- NO. 400. Read the following Circular letter from Colonel W. A. CROMMELIN, R.E., Deputy Secretary to the Government of India, Public Works Department, (Military Works), to the Governments of Madras, Bombay, Bengal, North-Western Provinces, and the Punjab, in the Public Works Department; the Chief Commissioners, Oudh, Central Provinces, British Burmah, Mysore and Coorg, and Assam; the Resident at Hyderabad; the Agents of the Governor-General for Central India and Rajpootana; the Superintendent of Port Blair, and Chief Commissioner of Andaman and Nicobar Islands; the Inspector-General of Military Works, dated Fort William, 13th March 1875, No. 29 P. W. :—

I AM directed to communicate, for general information and guidance, the following notes relating to alterations and improvements of the standard design of ovens for bakeries issued with Public Works Department Circular No. 117, dated 19th December 1867 :—

CIRCULAR No. 29 PUBLIC WORKS.

Alterations and improvements in standard design of ovens for bakeries.

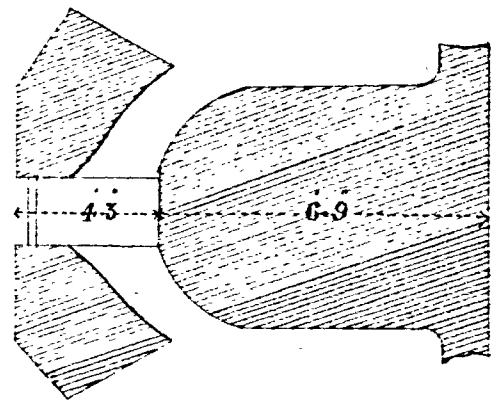
XX.—Passage from furnace to ovens to be as near the front of ovens as possible, and rounded, *vide* margin.
